MODIFICATIONS TO PREVIOUSLY
APPROVED NEW RESIDENCE @
310 CLARKE AVENUE
PALM BEACH, FL 33480
ARC-23-137
ZON-23-104

- DOCUMENT ARCHITECTURAL, HARDSCAPE, & LANDSCAPE CHANGES FROM PREVIOUSLY APPROVED ARCOM SUBMITTAL.
- APPLY FOR 6 ZONING VARIANCES AS FOLLOWS:
 - VARIANCE 1:SEC. 134-1669. A VARIANCE FOR AN EQUIPMENT YARD SCREENING WALL HEIGHT OF 7'-8",IN LIEU OF THE 7' MAX PERMITTED, IN THE WEST EQUIPMENT YARD.

Response to Comments 7/28/23

HARDSCAPE PLAN

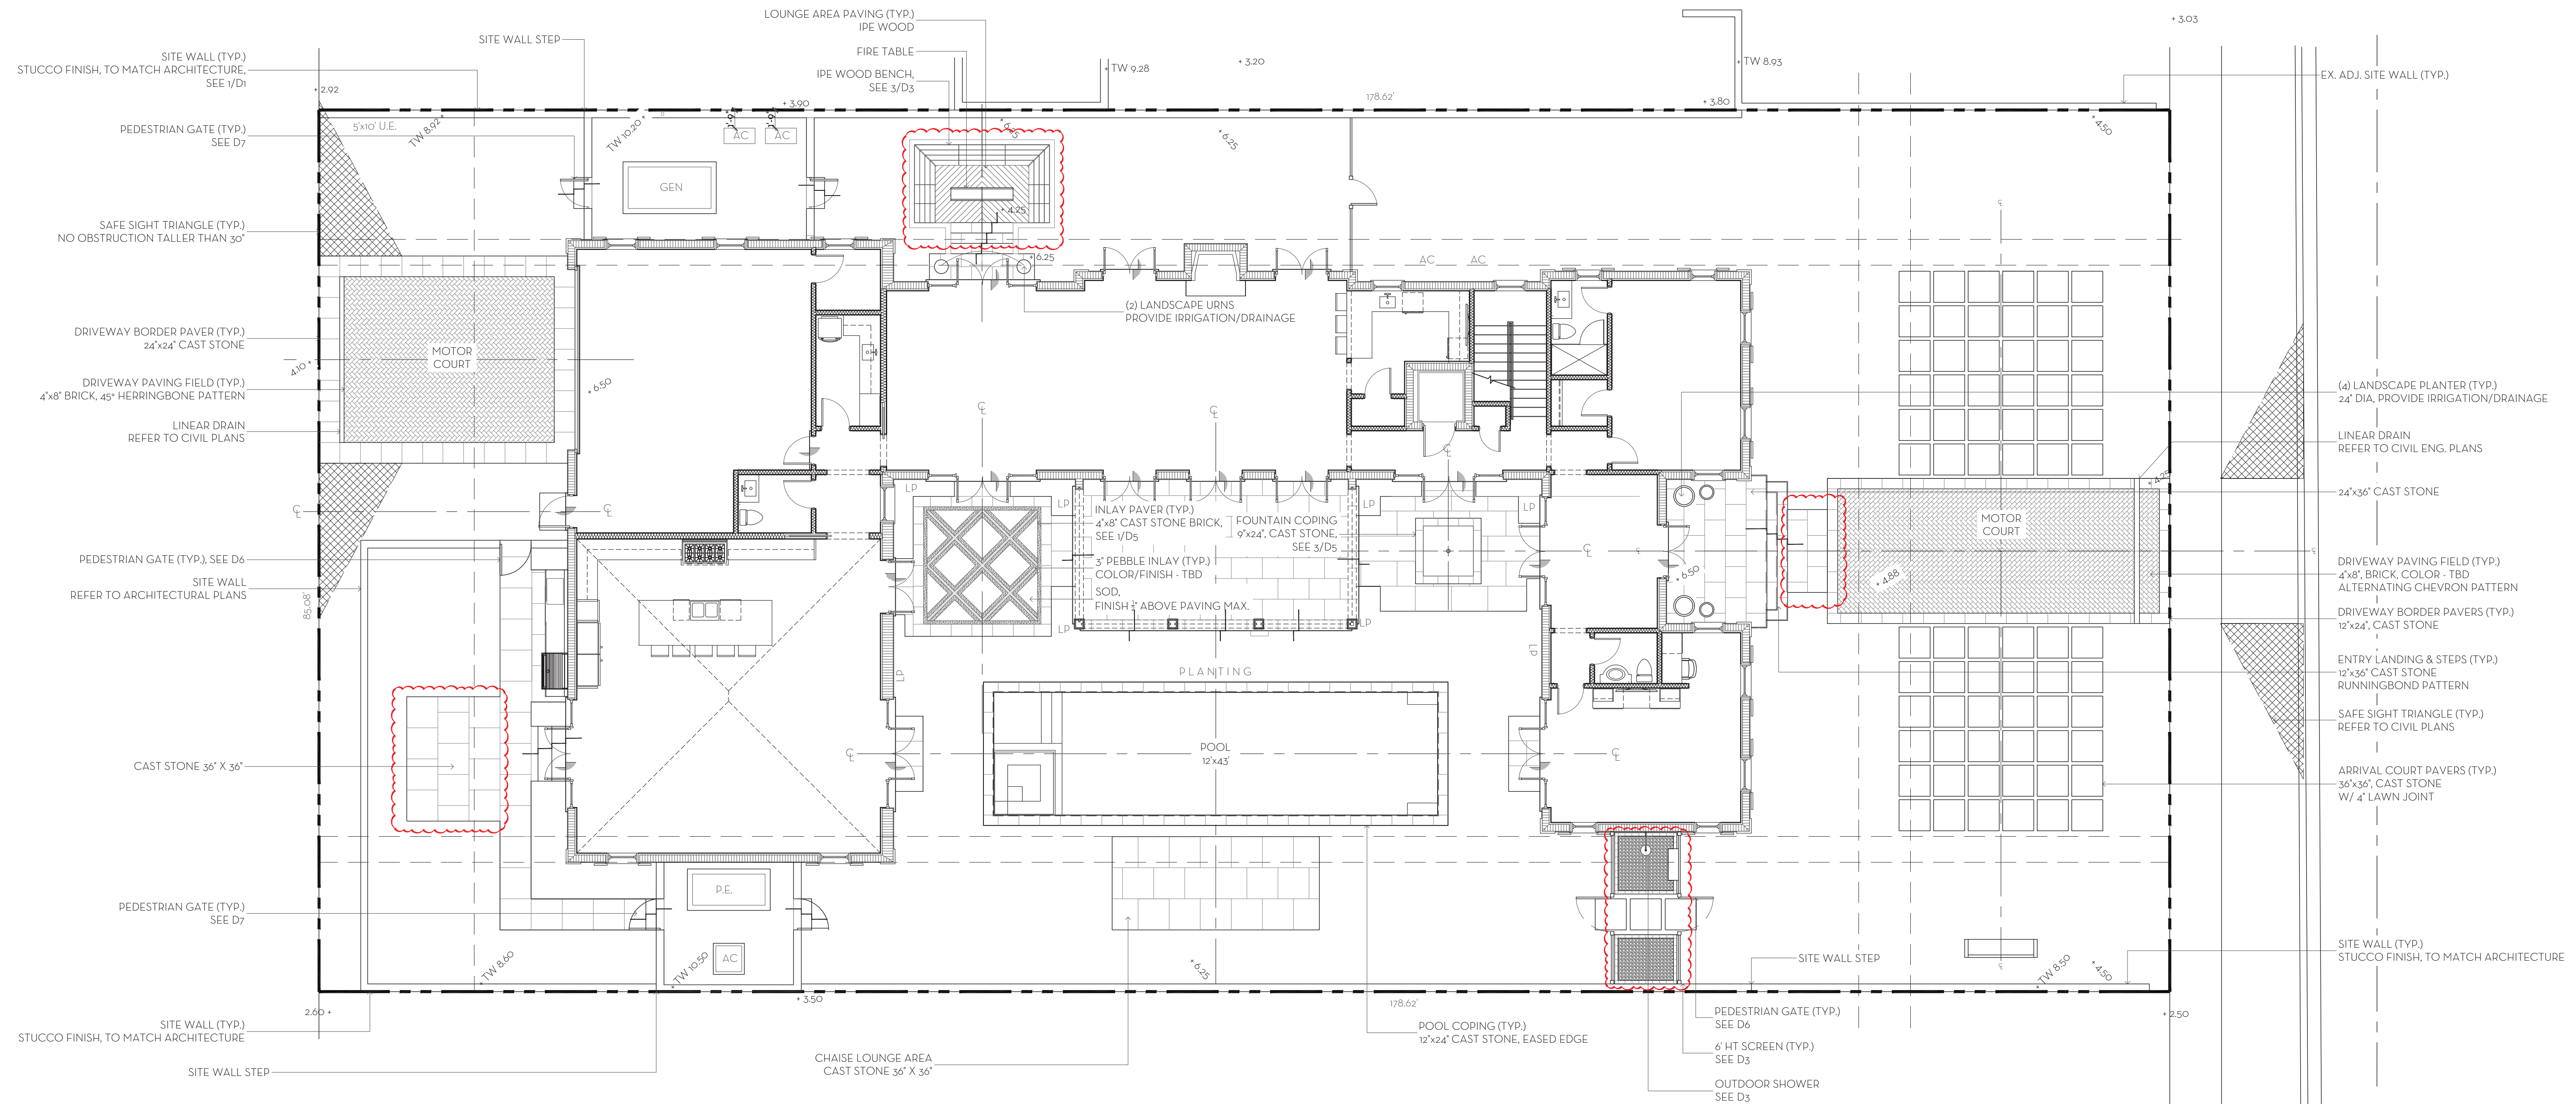
1. Provide a landscape open space diagram. Confirm that the landscape open space is correct, Hardscape is being added (south terrace, west lounge area, and north motorcourt seem to be increasing in size). *Landscape open space diagrams provided showing the required landscape open space being met. Hardscape removed from plan. North and east walkway removed. Terraces in pool courtyard removed. South walkway and west landings removed.*
2. Dimension from the west A/C units to the property line (they are moving from previously approved. *Refer to architect's plan.*
3. Provide detail of outdoor shower. *Details of outdoor shower provided on sheet D3.*
4. Materials and patterns are changing at the west lounge area and outdoor shower. Provide photo example of material and color. Provide depiction of pattern. *Material and patterns provided on sheet D3. Depiction of pattern provided.*
